## Charlotte Historic District Commission

# Application for a Certificate of Appropriateness

ADDRESS OF PROPERTY 323 Rensselaer Avenue, Dilworth Local Historic District HDC 2012-011

SUMMARY OF REQUEST Second Story Addition

FRONT ELEVATION 1/4" = 1'-0"

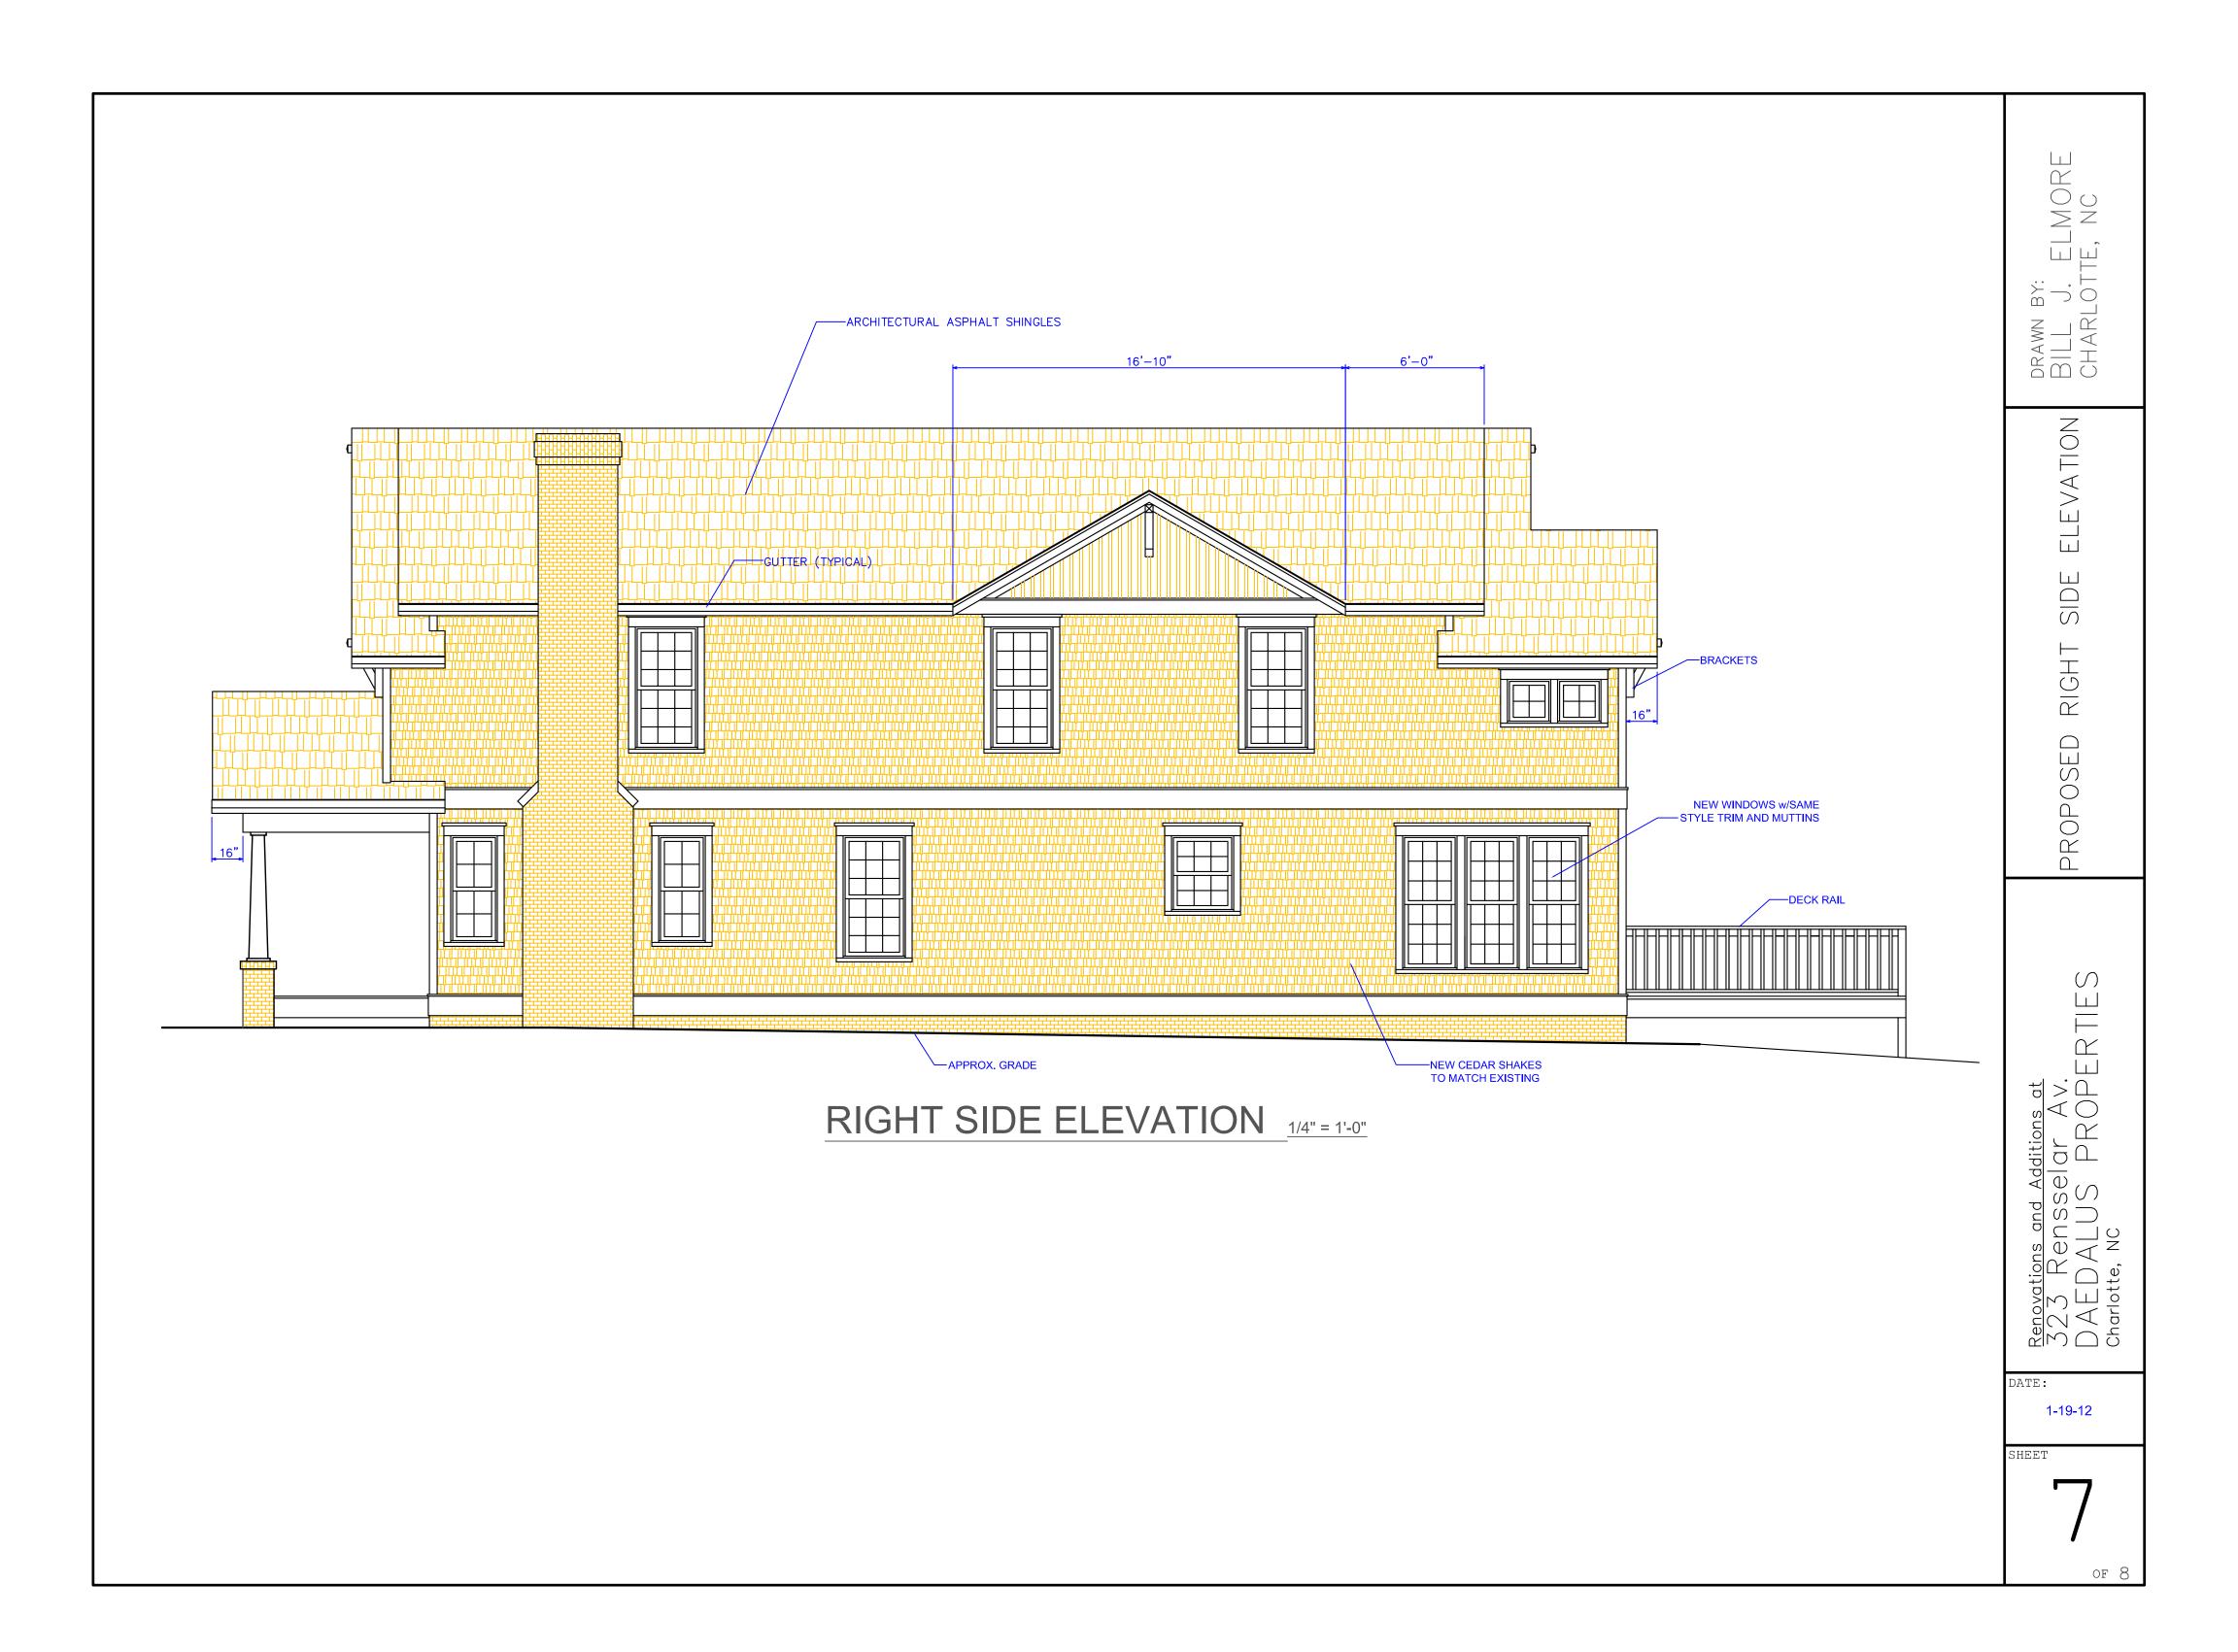
Currently, the house has a height at the front of roughly sixteen feet from finished floor. The new structure would be twenty-five feet, eight inches in height at the front elevation. The new second floor is an extension of the existing side walls of the house. Down the sides of the house in the new elevations, a wide band board separates the two floors, and small gables interrupt the eave line on the second floor.

Although the house currently has exposed rafter tails, the new plan shows what appear to be boxed eaves and eave brackets on the front and rear elevations.

# TYPICAL WOOD WINDOW

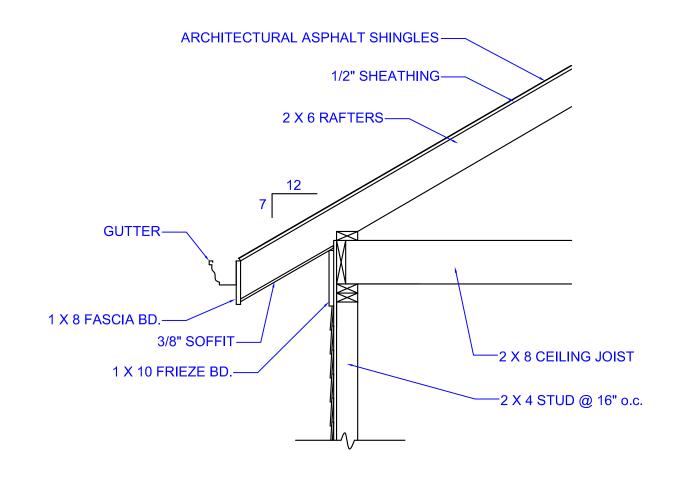
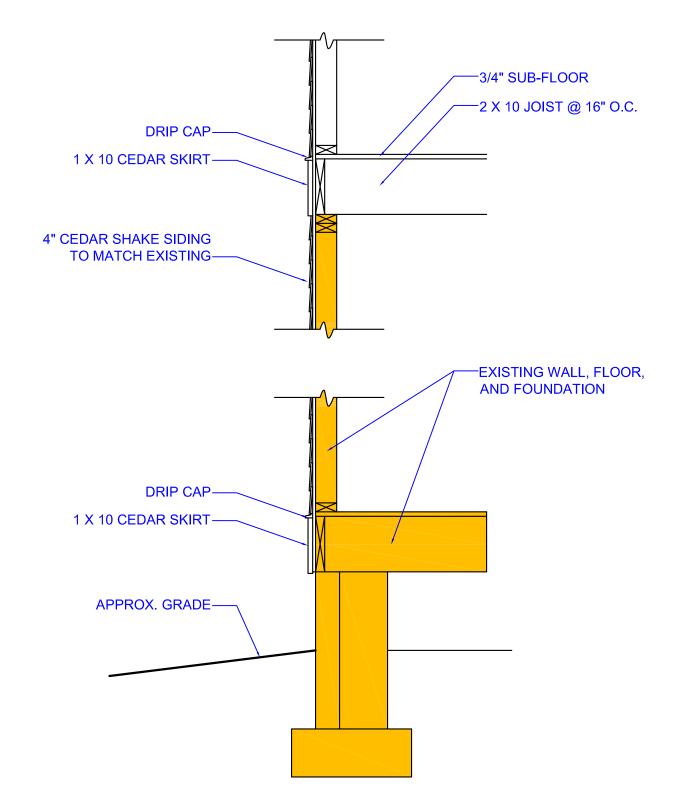
The plans also include the replacement of all the existing six over one windows on the first floor with new wood frame nine over nine windows.

EXISTING FLOOR PLAN W/PROPOSED PLAN 1/4" = 1'-0" 985 SQUARE FEET

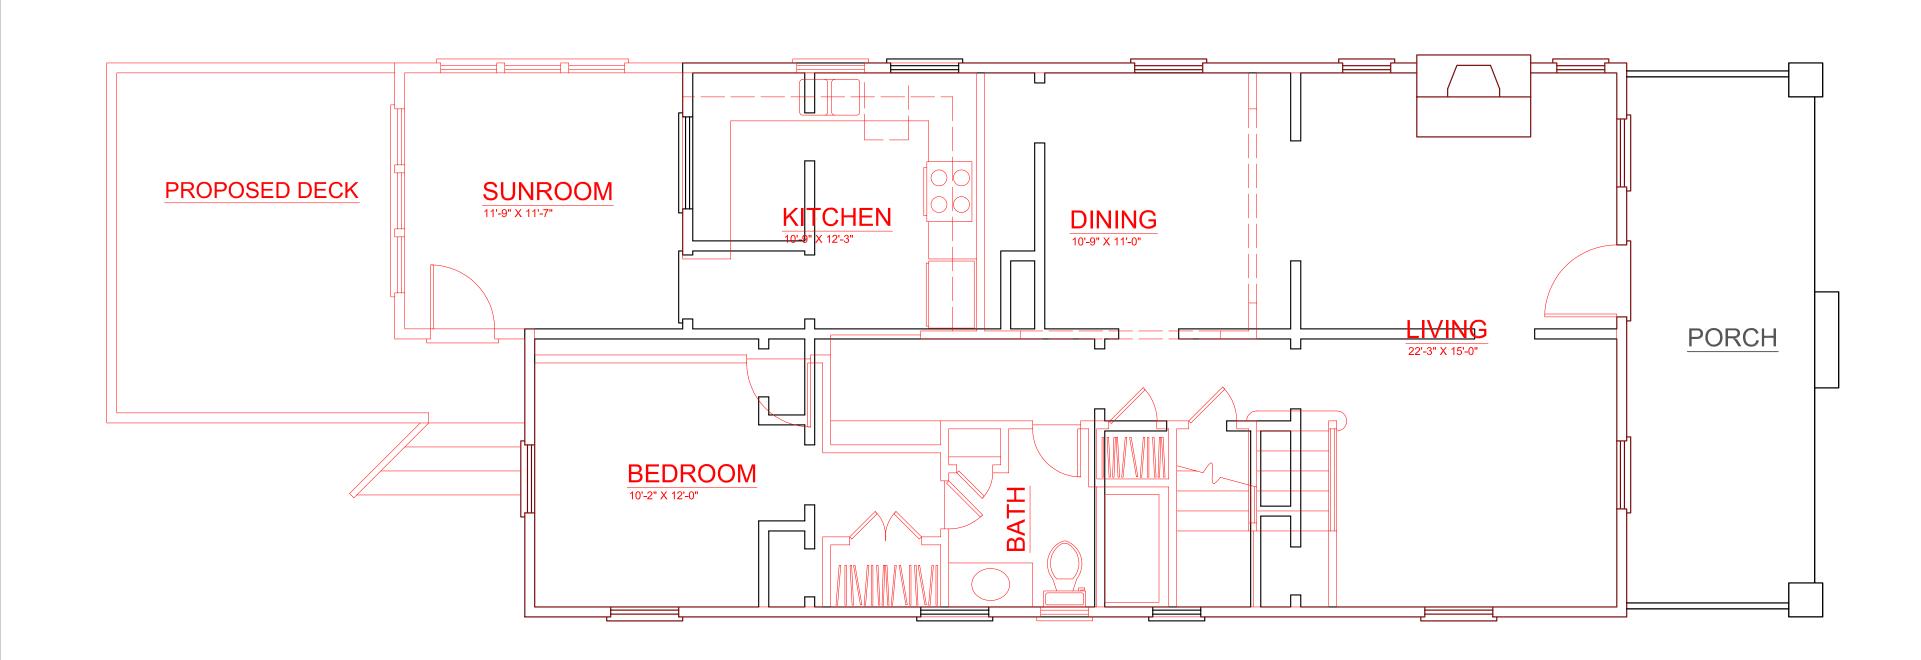
The attached plans show a conversion of this house into a full two story structure under a front-facing gabled roof. The only change to the existing footprint of the house is a twelve foot rear sunroom addition and a rear deck, neither of which is wider than the existing structure. An existing chimney on the right side of the house would be extended in place to accommodate the new height of the house.
